RECALL CAMPAIGN BULLETIN

NTB04-100a

VOLUNTARY RECALL CAMPAIGN SKYVIEW ROOF GLASS

APPLIED VEHICLE: 2004 Maxima (A34)

Figure 10

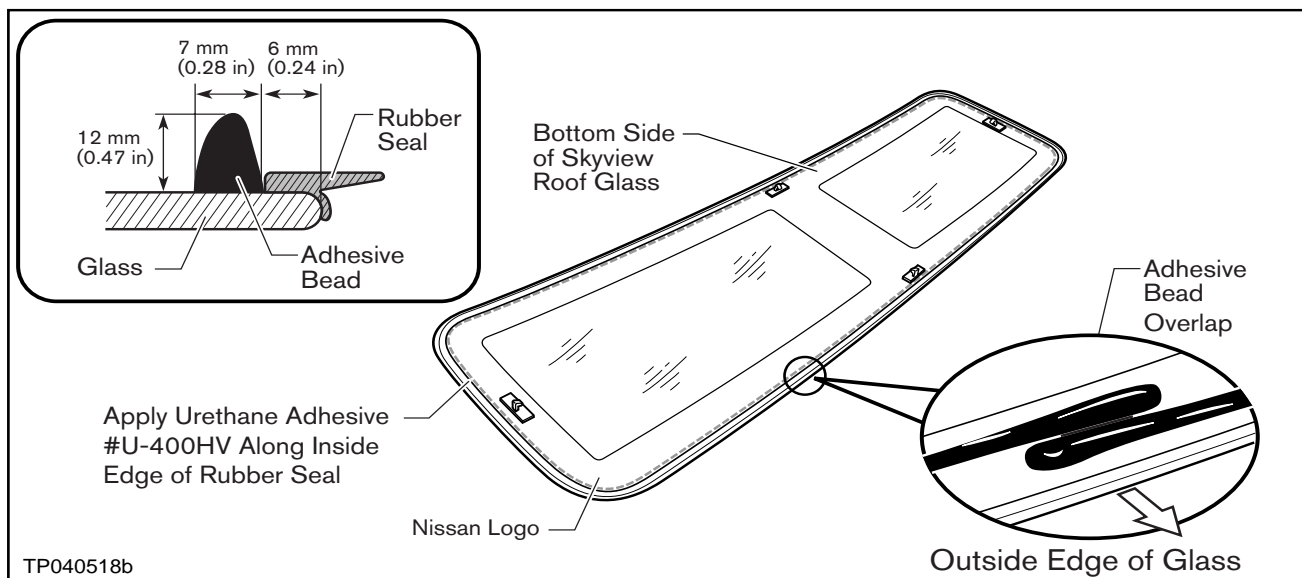
- Figure 10 (page 7) was revised to include a rubber seal on the glass.
 - Please use this bulletin (NTB04-100a) ONLY.
 - Discard all previous copies of NTB04-100.

13. Apply a bead of Urethane Adhesive to the new Skyview Roof Glass over the Primer coats (see Figure 10).

- Use Essex Betaseal Urethane Adhesive #U-400HV (“Rapid Cure Auto Glass Urethane Adhesive”) or equivalent. Follow the instructions supplied with the Adhesive.
- Adhesive bead size should be 12 mm high and 7 mm wide.
- Apply Adhesive around the Glass, on top of the U-402 that you just applied, so the adhesive bead runs along the inside edge of the rubber seal (see Figure 10).
- Go past the start point to ensure overlap before ending the bead.
- The Adhesive starts to set up quickly. You’ll have to install the glass right away.
- Do NOT touch the Adhesive.
